GRADING AND DRAINAGE PLAN

Santuario
San Martin De Porres
8301 Camino San Martin SW
Westgate Heights
Albuquerque, NM 87121

JANUARY 25, 2010
**SITE PLAN
FOR
BUILDING PERMIT**

ADMINISTRATIVE AMENDMENT

CONCEPTUAL SITE PLAN
1" = 30'

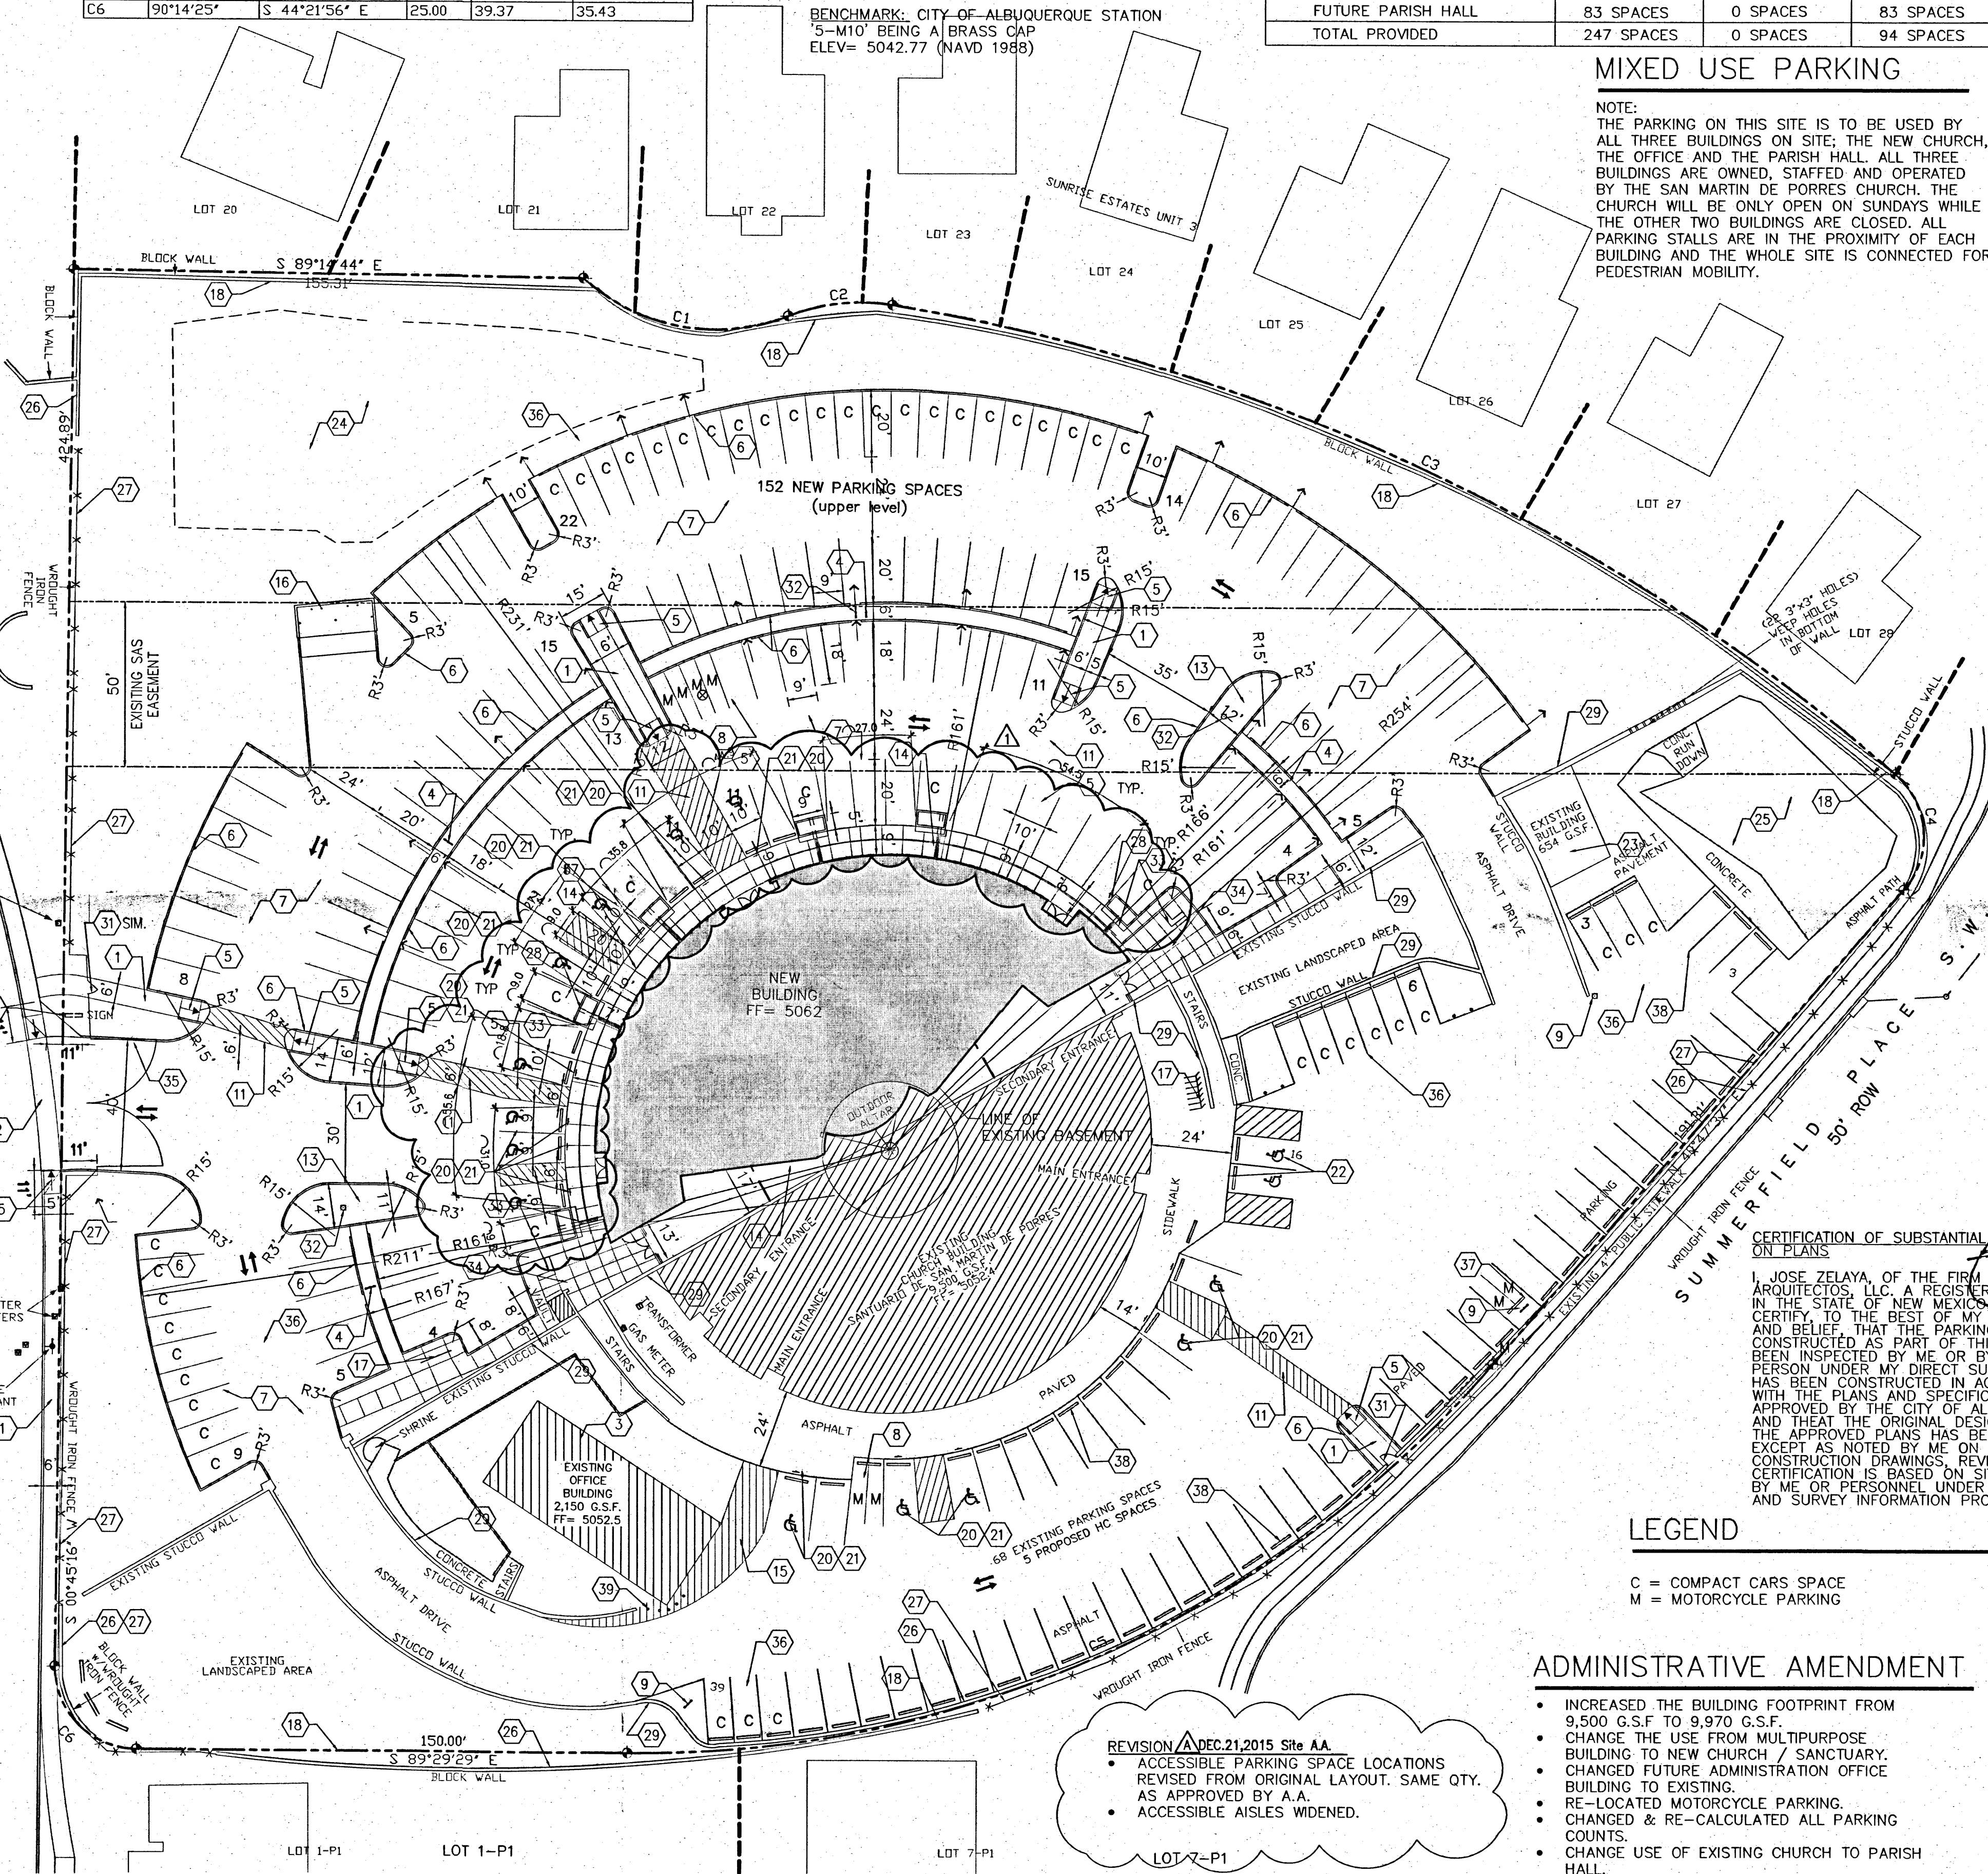
- INCREASED THE BUILDING FOOTPRINT FROM 9,500 G.S.F. TO 9,970 G.S.F.
- CHANGE THE USE FROM MULTIPURPOSE BUILDING TO NEW CHURCH / SANCTUARY.
- CHANGED FUTURE ADMINISTRATION OFFICE BUILDING TO EXISTING.
- RE-LOCATED MOTORCYCLE PARKING.
- CHANGED & RE-CALCULATED ALL PARKING COUNTS.
- CHANGE USE OF EXISTING CHURCH TO PARISH HALL.
- REQUEST FOR SHARED PARKING FOR NON-CONCURRENT USE.

REVISION DEC.21.2015 Site AA
• ACCESSIBLE PARKING SPACE LOCATIONS REVISED FROM ORIGINAL LAYOUT. SAME QTY. AS APPROVED BY A.A.
• ACCESSIBLE AISLES WIDENED.

CONCEPTUAL SITE PLAN

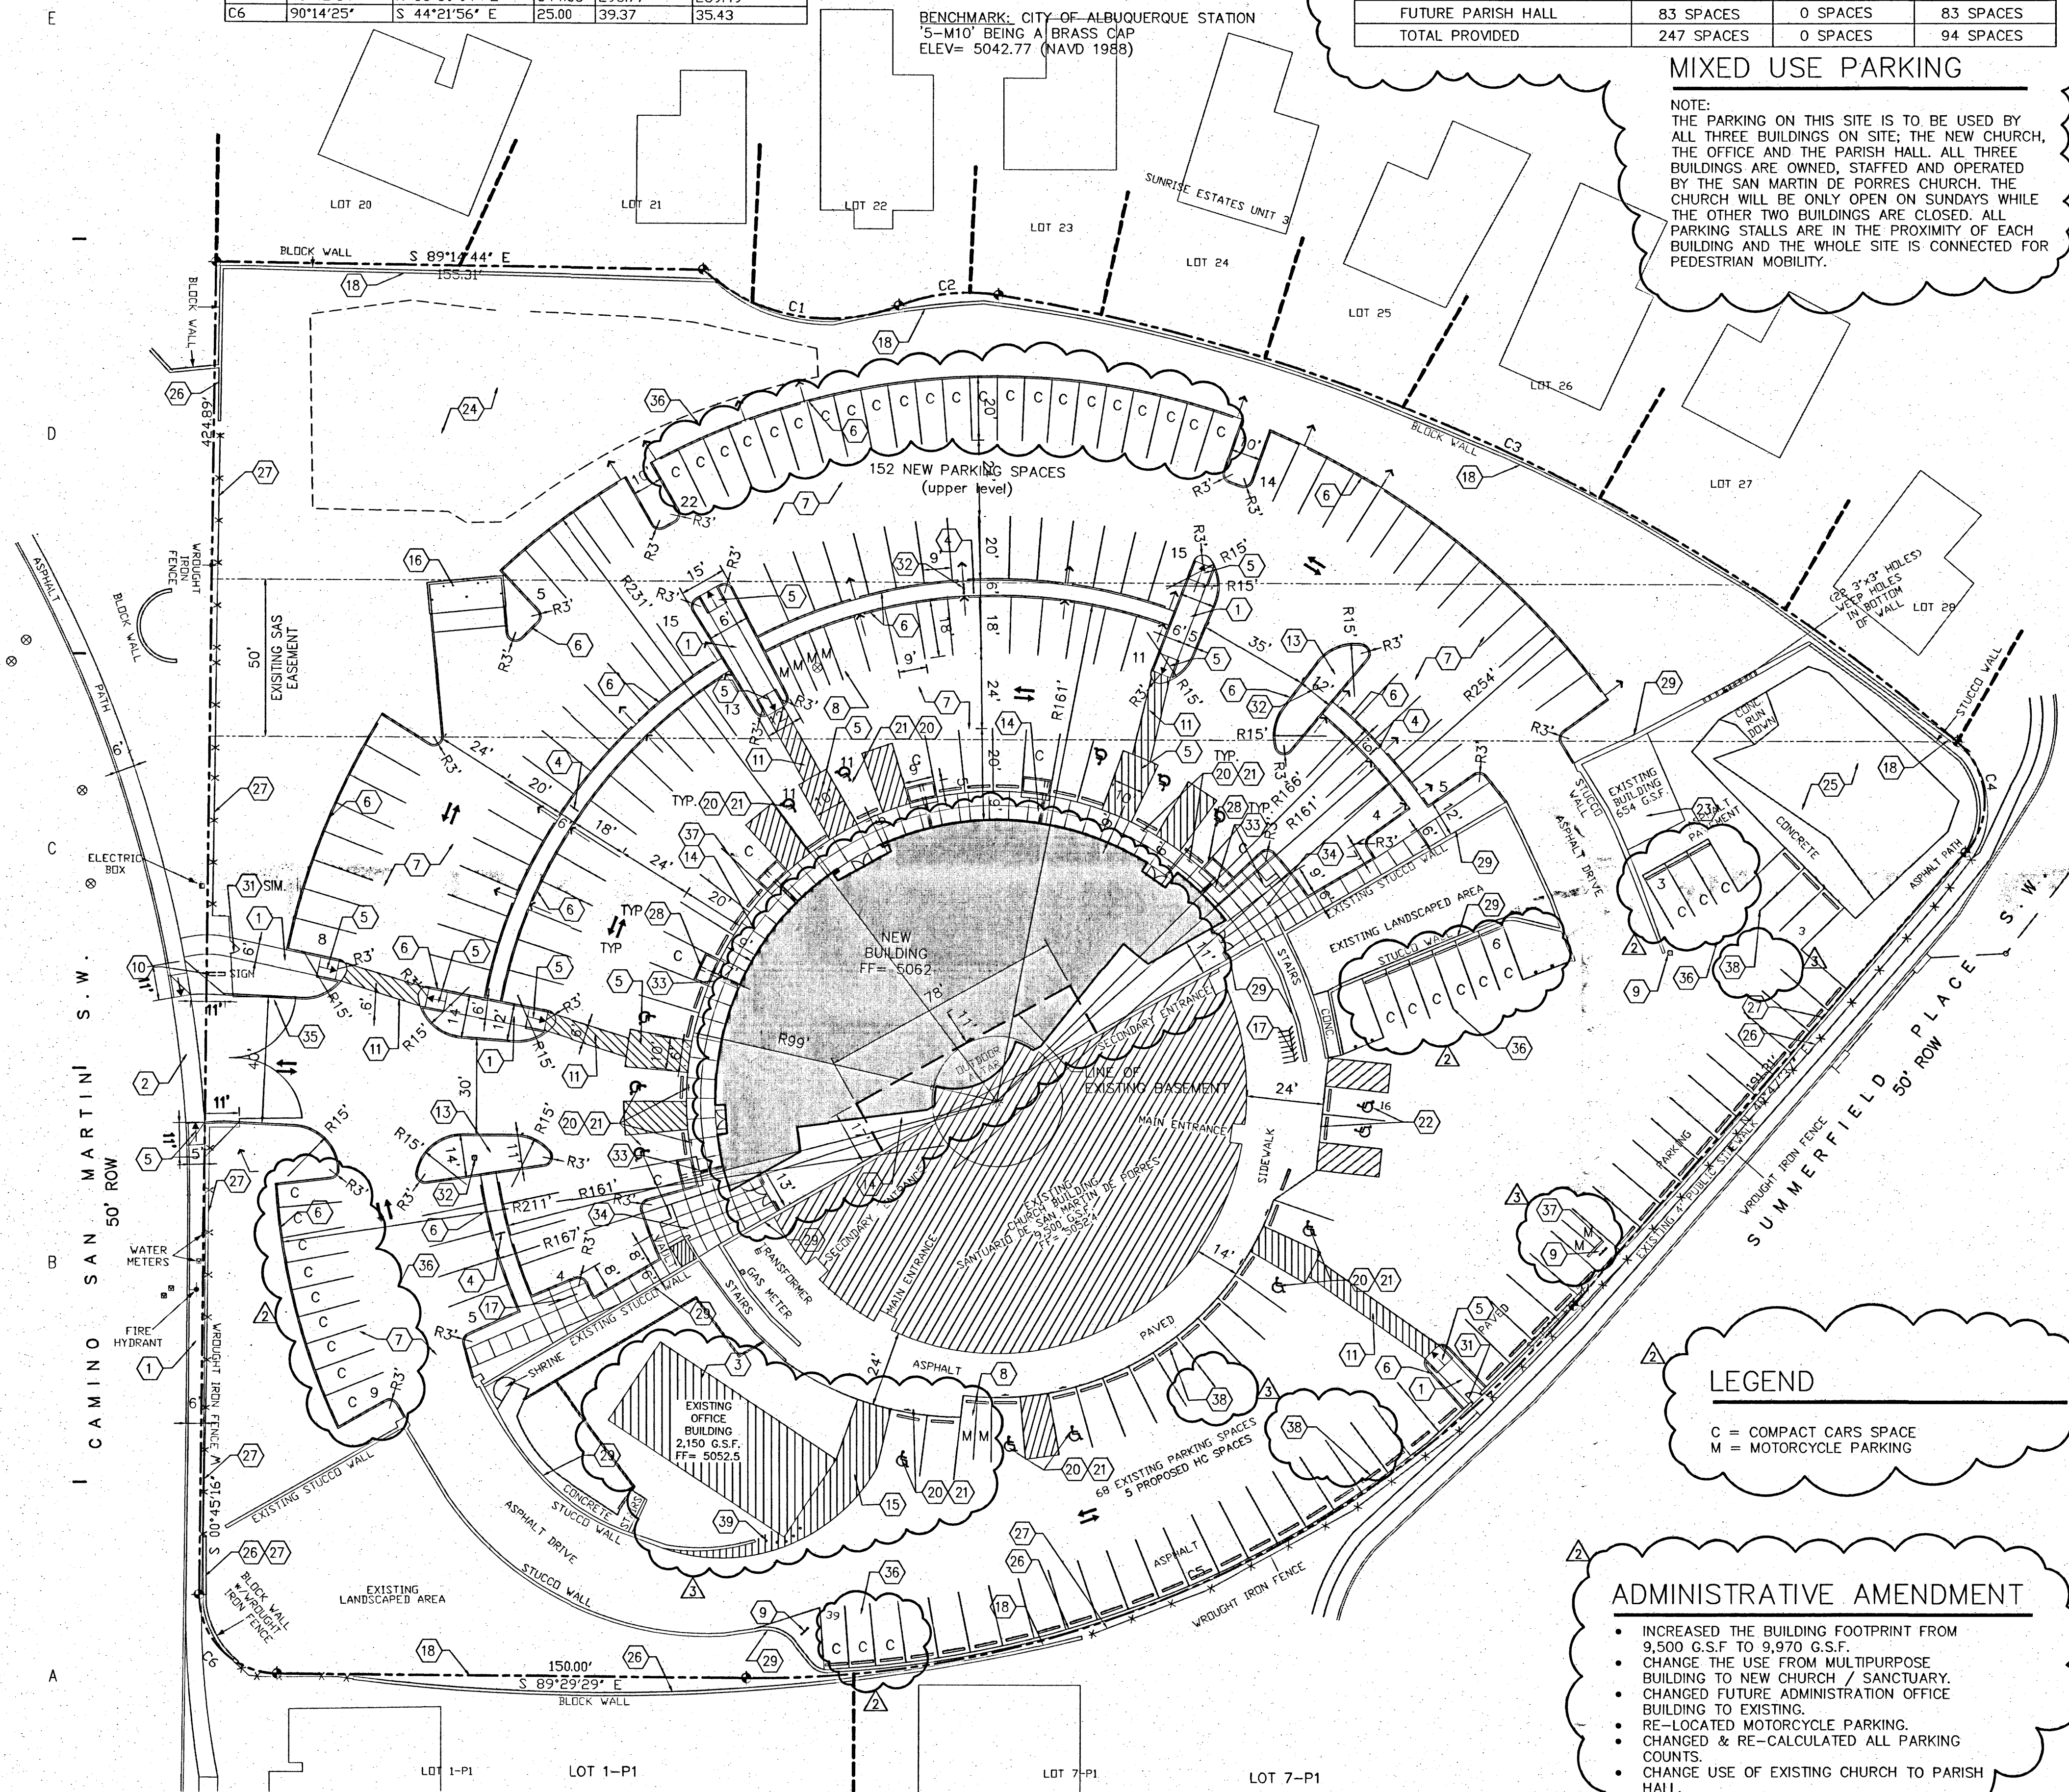
- INCREASED THE BUILDING FOOTPRINT FROM 9,500 G.S.F TO 9,970 G.S.F.
- CHANGE THE USE FROM MULTIPURPOSE BUILDING TO NEW CHURCH / SANCTUARY.
- CHANGED FUTURE ADMINISTRATION OFFICE BUILDING TO EXISTING.
- RE-LOCATED MOTORCYCLE PARKING.
- CHANGED & RE-CALCULATED ALL PARKING COUNTS.
- CHANGE USE OF EXISTING CHURCH TO PARISH HALL.
- REQUEST FOR SHARED PARKING FOR NON-CONCURRENT USE.
